**ATTACHMENTS FOR: AGENDA NO. 10/20
COUNCIL MEETING**

Item		Page
10	PLANNING PROPOSAL 2-6 CHATHAM ROAD, WEST RYDE - Outcomes of Exhibiton	
	Attachment 1 Planning Proposal as Exhibited	1
	Attachment 2 Council Meeting Minutes 6 December 2016	61
	Attachment 3 Gateway Determination 16 February 2017	62
	Attachment 4 Gateway Alteration 1 February 2018	66
	Attachment 5 Gateway Alteration 3 July 2018	68
	Attachment 6 Gateway Alteration 7 December 2018	70
	Attachment 7 Submissions and Responses Table.....	72
	Attachment 8 Proponent's Submission	95
	Attachment 9 Built Form Strategy	100
	Attachment 10 Proposed DCP Amendment	104
	Attachment 11 Design Review Panel Comments	150

2-6 Chatham Road, West Ryde | February 2017

Figure 01. Built form concept plan

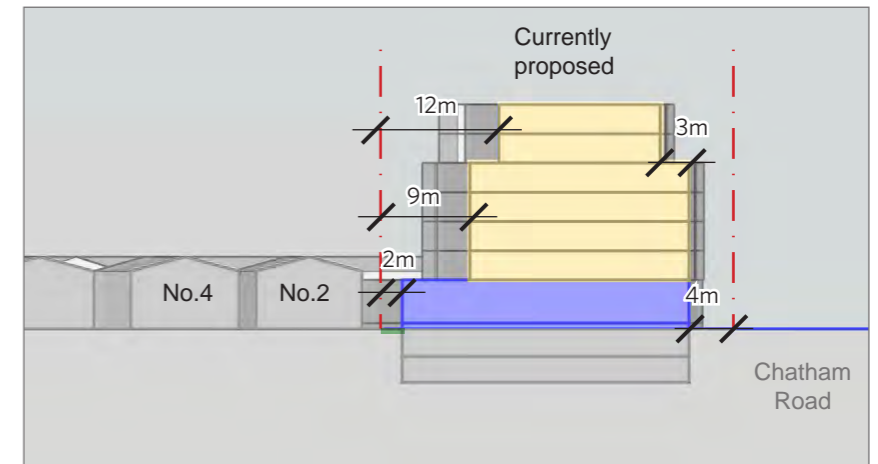
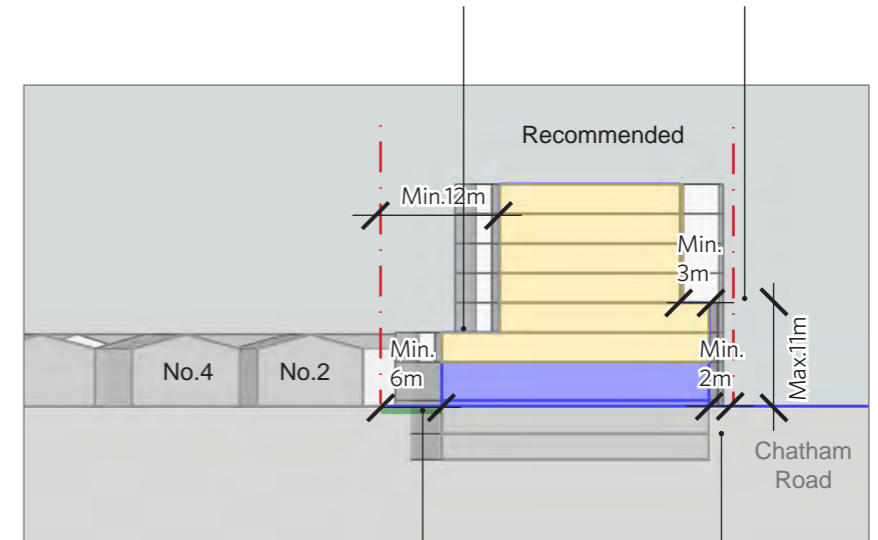
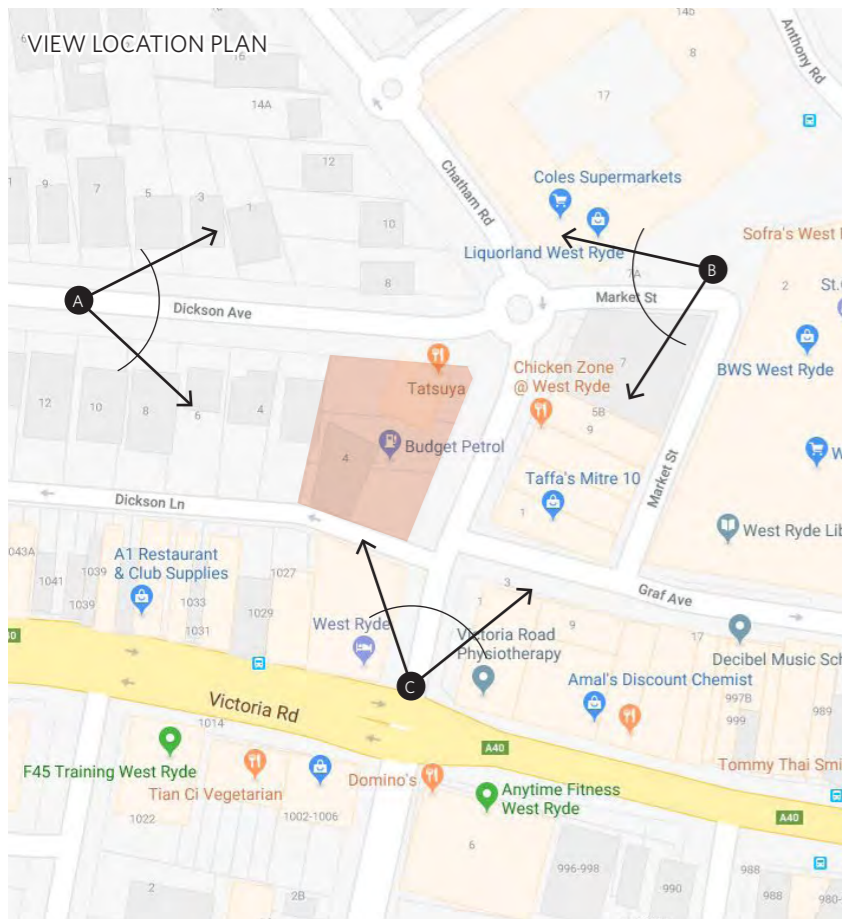
Step down built form to provide a sensitive response to the R2 zone. Maintain a sympathetic street wall height to the context.

Increase separation to provide an adequate landscape buffer. Bring building forward to help alleviate potential impacts on the neighbouring property.

- A minimum of 3m secondary setback is to be provided above the third storey (L2) on Chatham Road and Dickson Lane as per Figure 01.
- A minimum of 3m secondary setback is to be provided above the second storey (L1) on Dickson Avenue as per Figure 01.
- No secondary setback is required at the corner of Chatham Road and Dickson Avenue in order to create a vertical built form to mark the corner.

Figure 02. View due east on Dickson Avenue

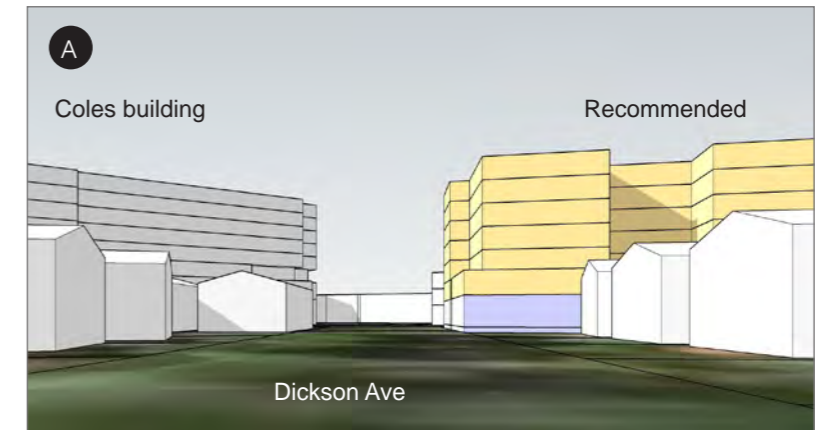
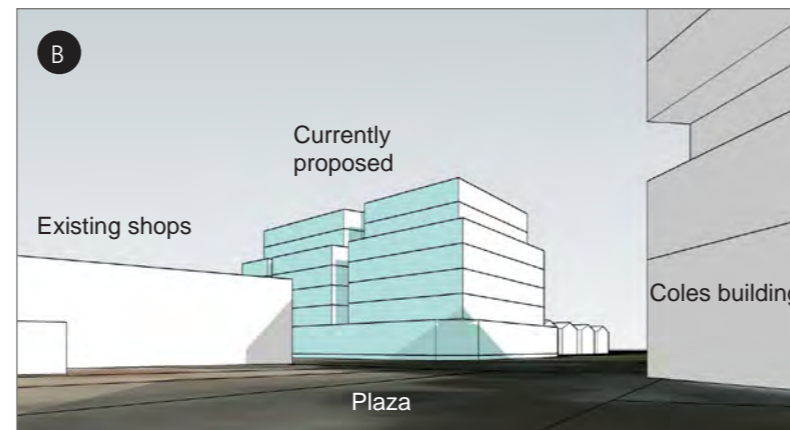
The proposal presents a long and continuous built form when viewed from the public domain of Dickson Avenue. The perceived bulk of the proposal is excessive, especially with the low-scale dwelling houses in the foreground.

A U-shape configuration is more appropriate as it has a more sensitive built form to the R2 zone with greater building separation and a reduction in the perceived bulk.

Figure 03. View due southeast from the plaza

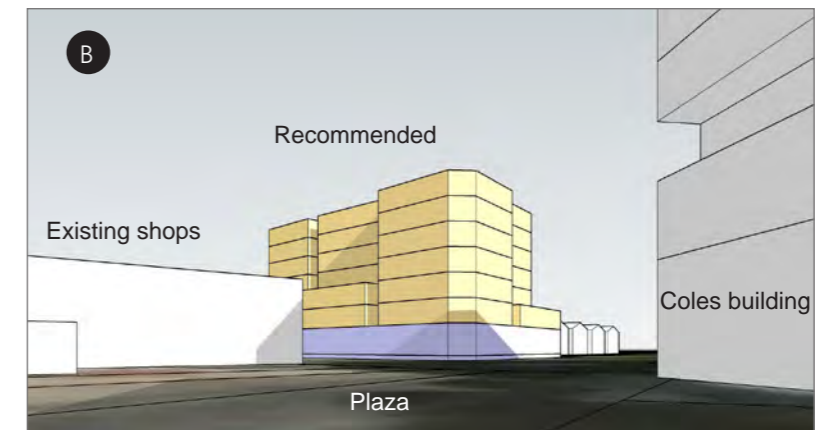
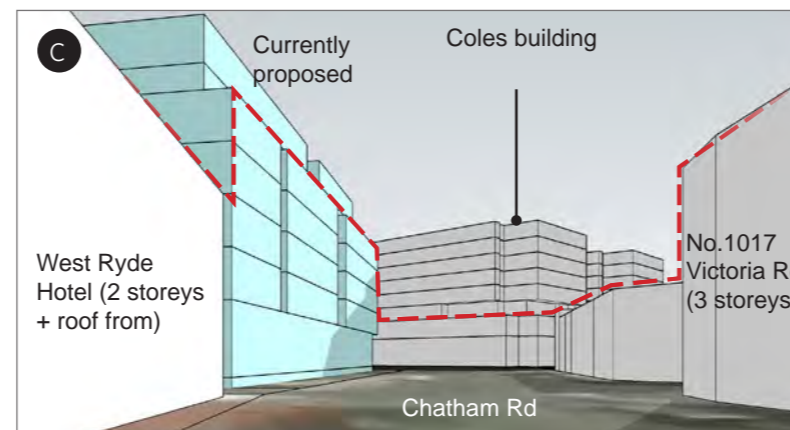
The form of having 5-storey street wall with 2 recessed storeys above does not help to achieve an elegant proportion for the 7 storey building.

It is recommended to articulate and add visual interest to the development by creating a vertical built form to emphasise the Dickson Ave/Chatham Rd corner without additional building height.

Figure 04. View due north on Chatham Road

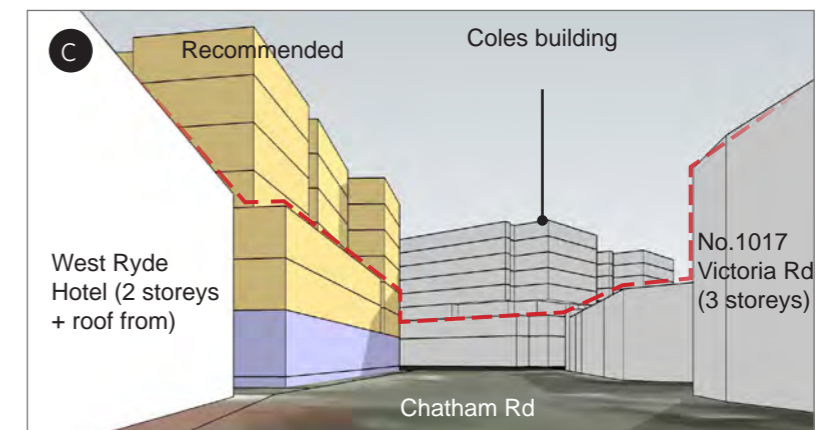
The proposed 5-storey high street wall is inconsistent with the existing streetscape character which predominantly has a street wall height of 2 to 3 storeys (red dotted line).

A 3-storey street wall height achieves a sympathetic streetscape relationship with the context (red dotted line).
